DESIGN PUBLIC HEARING WEBINAR

BRUCE FREEMAN RAIL TRAIL

Project No.: 608164

IN SUDBURY AND CONCORD, MASSACHUSETTS

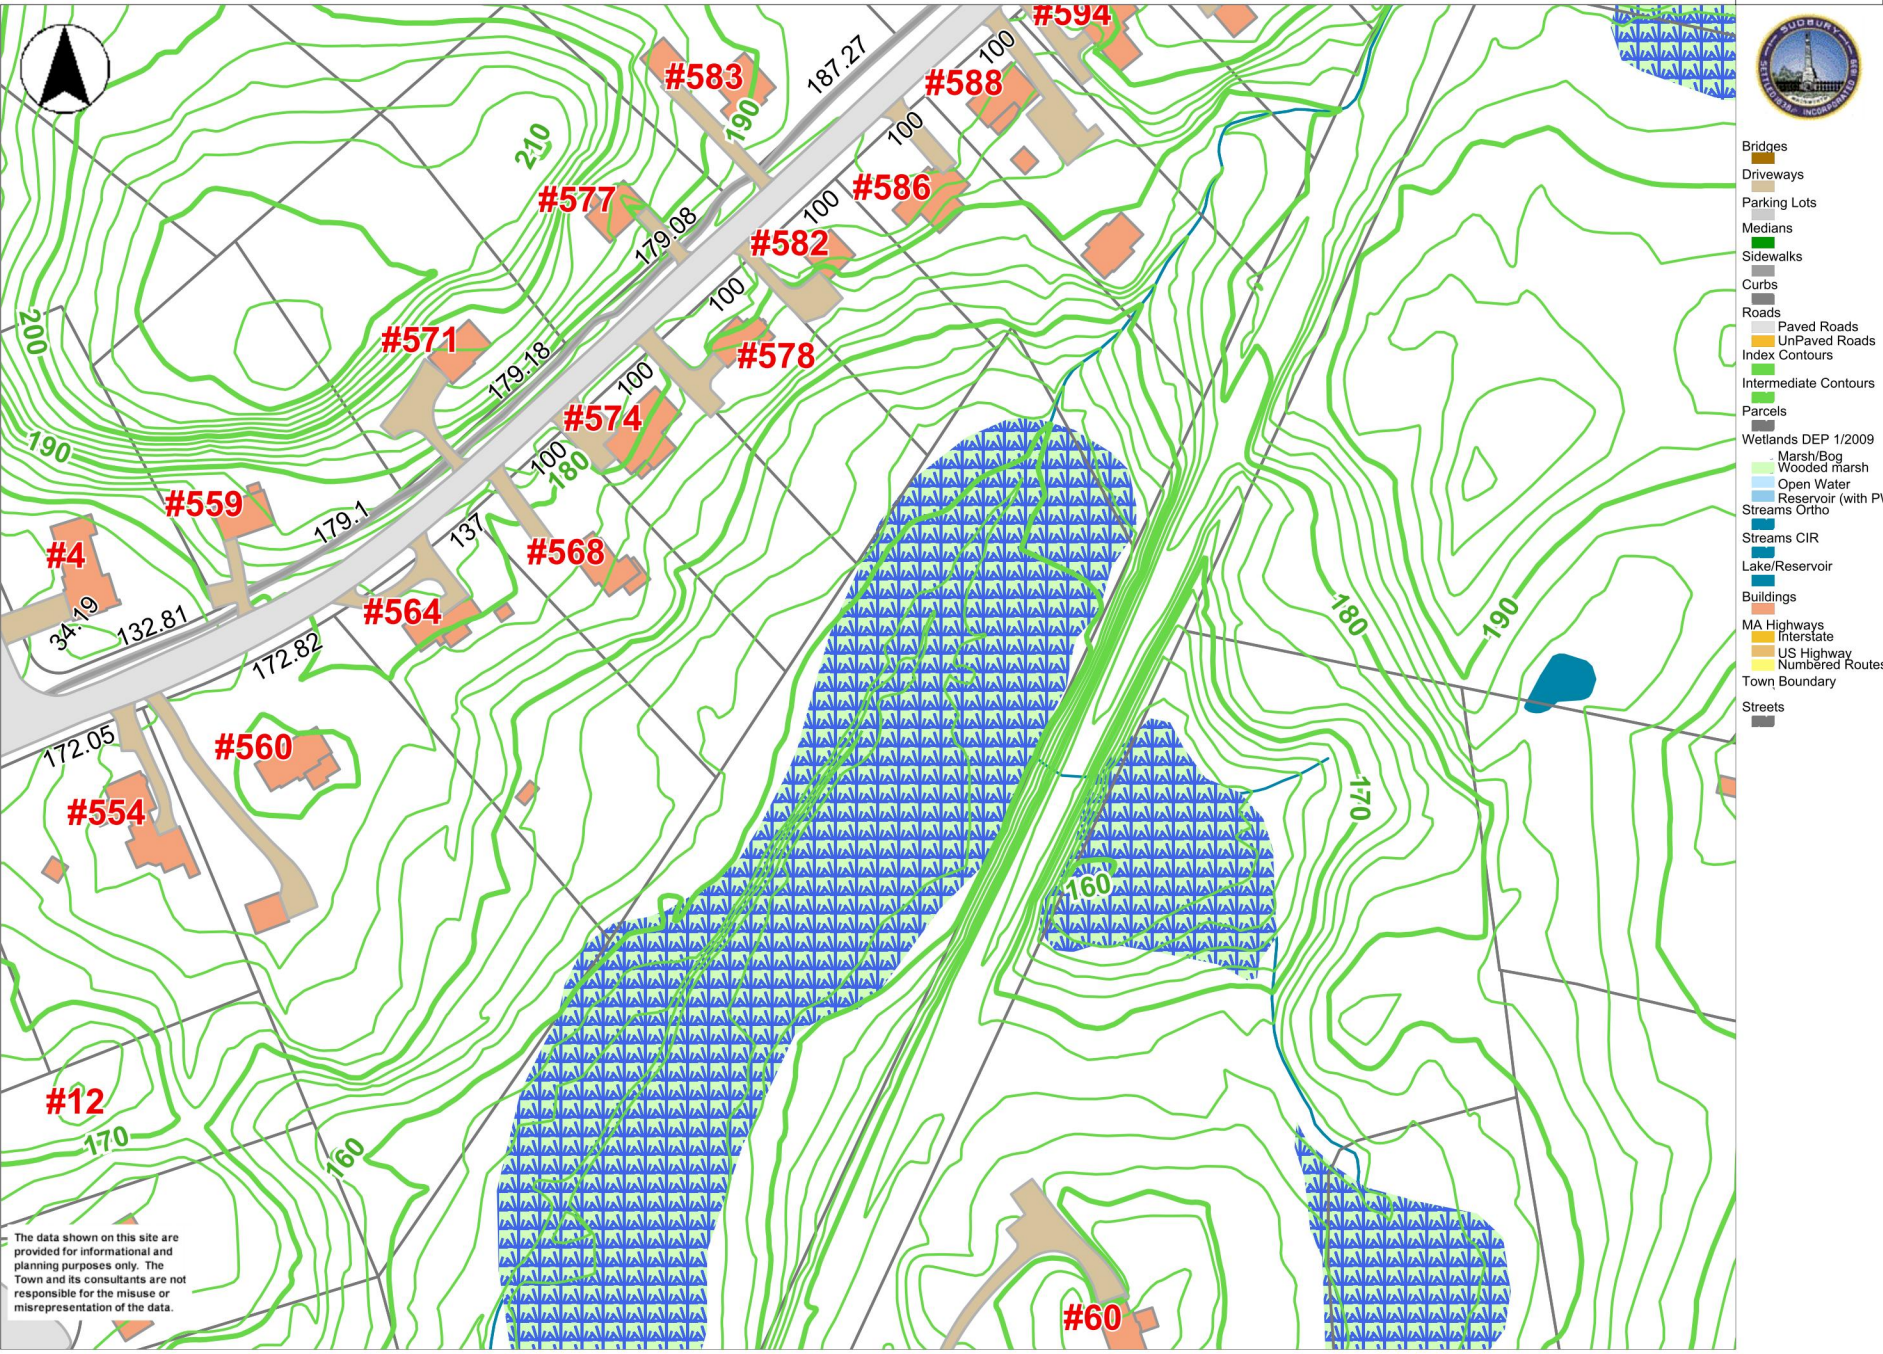
- 8) The Hudson Road intersection with the trail is about 800 feet west of the Hudson/Concord Road intersection at Town Center, and about 1,100 feet east of the Hudson/Maynard road split in front of the Police/Fire Public Safety complex at #75 and #77 Hudson Road, respectively. The driveway leading to the proposed parking at Ti-Sales is about 220 feet west of the trail crossing on Hudson Road. Peakham Road, another heavily traveled road, enters Hudson Road from the south immediately to the west of the trail crossing. There is a business exit about fifty feet east of the trail crossing, as well. (#608164_HudsonRoadCrossing.pdf, attached.) Town Center (which is not a right-angle crossing) has a traffic signal but there is currently no traffic signal at the Hudson/Maynard Road intersection. All these crossings (Town Center, Peakham, and Maynard) seriously back up at peak periods, such that police and fire have marked off areas of Hudson Road on which traffic may not stop so that emergency vehicles can get onto the road at need. Backup occurs both eastbound and westbound on Hudson Road from the Town Center and Maynard Road intersections. Adding HAWK signals for trail users will exacerbate this. Installing a traffic signal at the Peakham/Hudson intersection would not only confuse things further, it’s not clear that there would be an open lane on Hudson for traffic to enter even after receiving a green light. (Note on the attachment that the “road” north of Hudson

facing Peakham is actually not a road, but a private driveway for a business that carries considerable large truck traffic.) Prioritized emergency vehicles are further confusing factor. Please consider holistically traffic from Maynard Road to Town Center and evaluate putting a traffic signal at the Hudson/Maynard Road crossing and coordinating this with the signal at Town Center, rather than considering a traffic signal at Peakham Road.

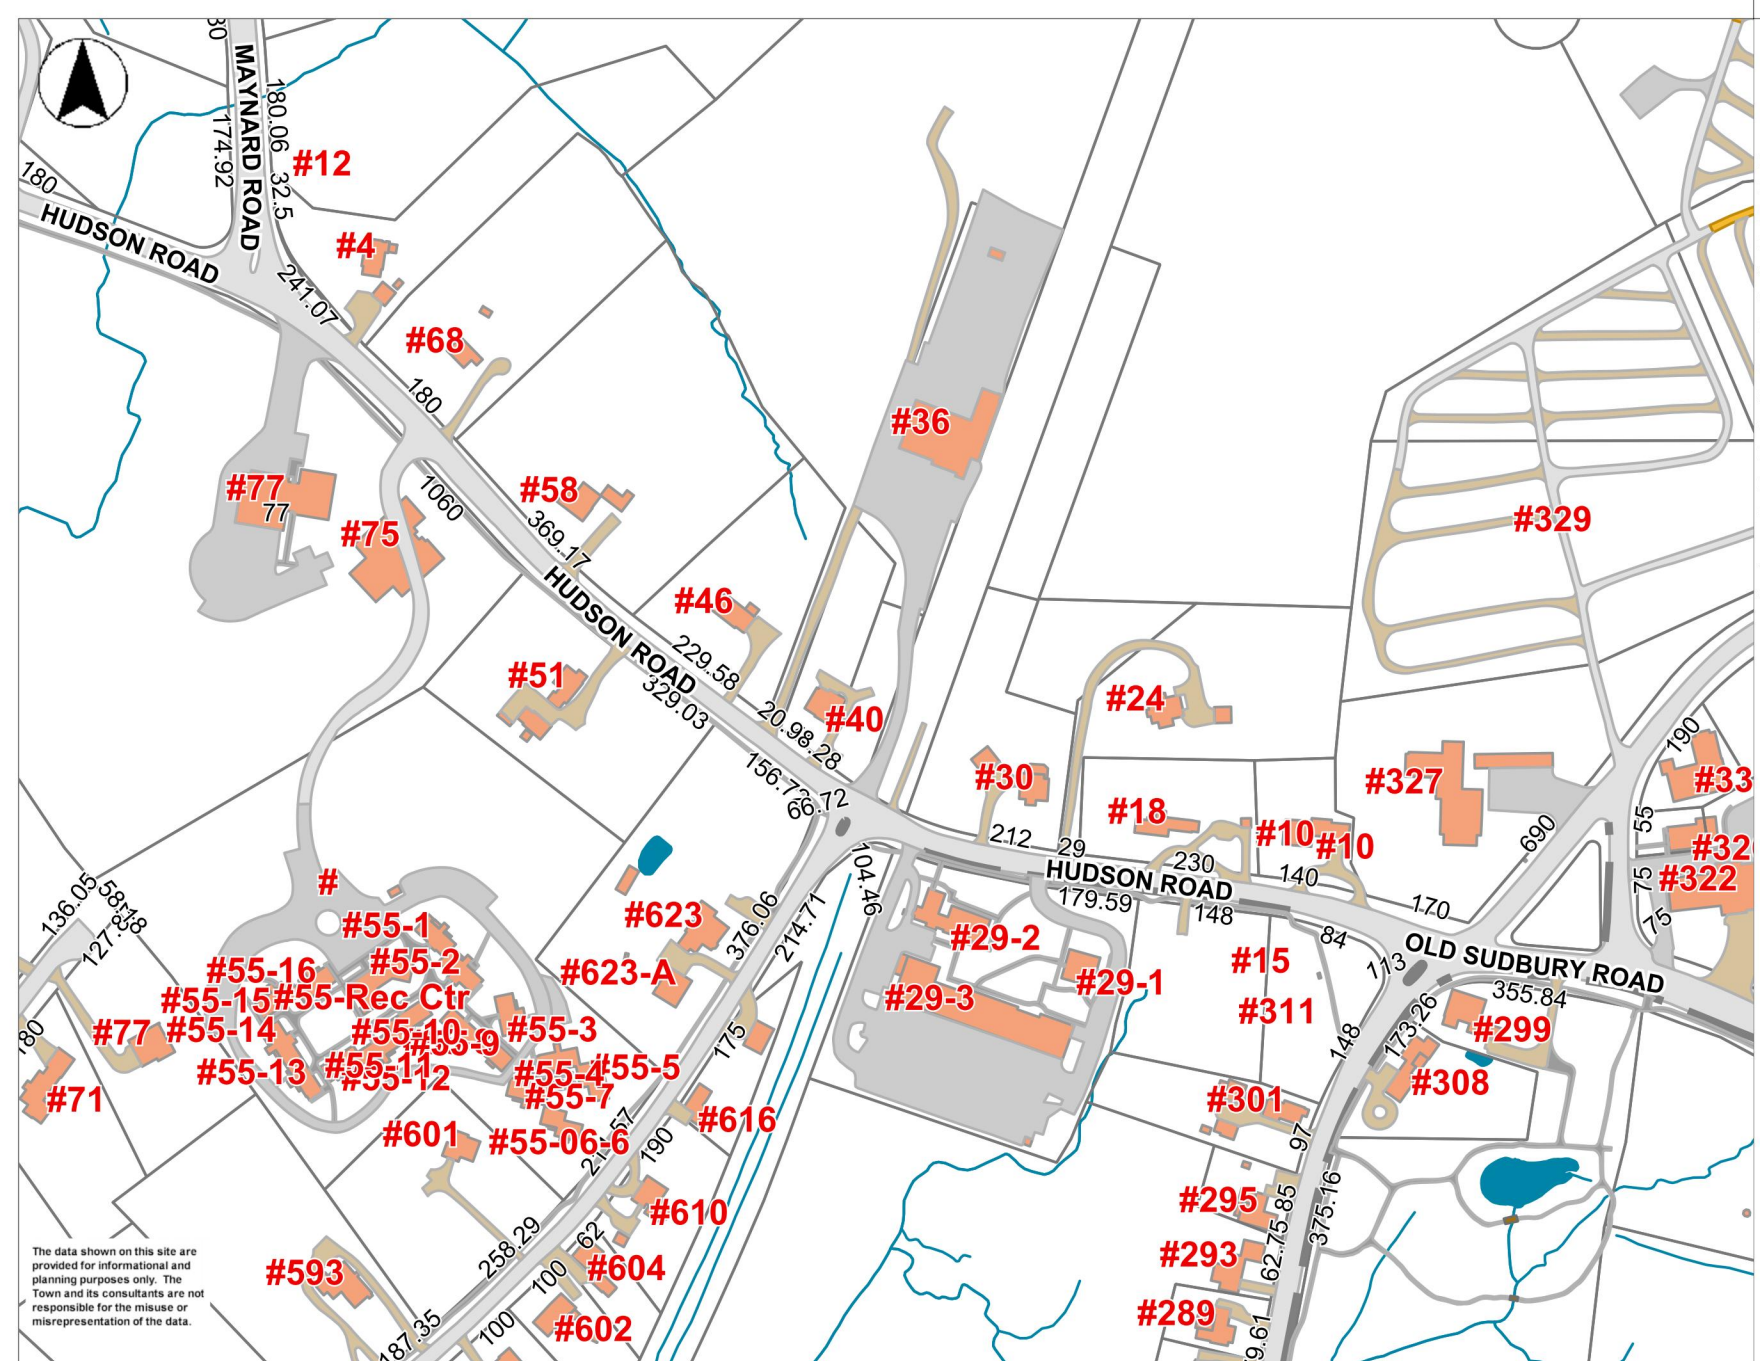
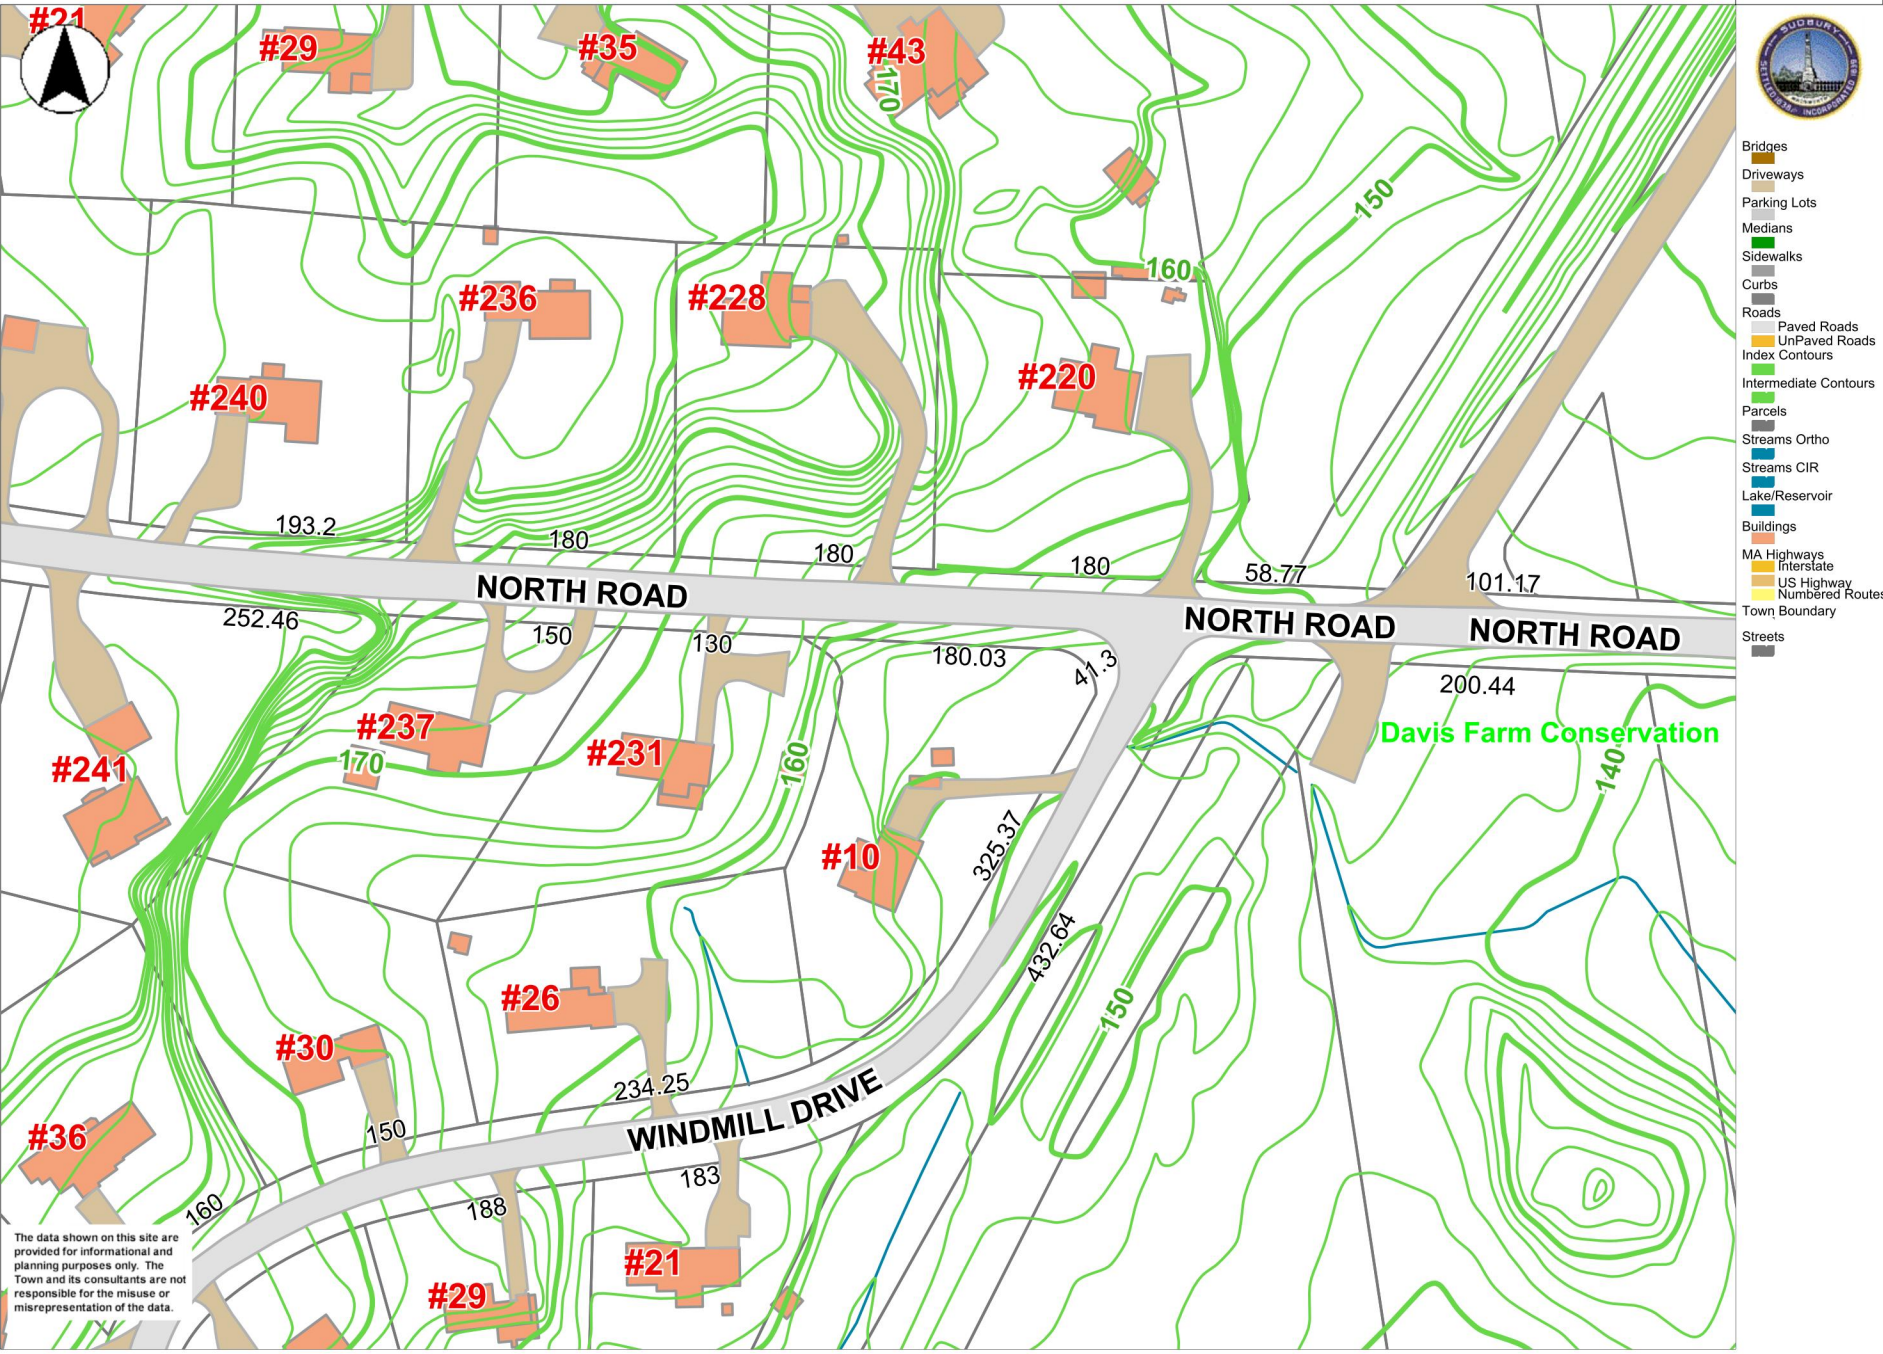
I mentioned previously that access to the southern terminus of this project is problematic (Comment #4, July 27, 2020). I would like to expand on that. I have attached the town GIS map of that area, showing the extent of the MassDOT (EOT) owned right of way outlined in yellow, and the MBTA corridor outlined in red. The two tiny unmarked parcels to the north of the MBTA corridor are owned by a private company as part of a larger parcel.
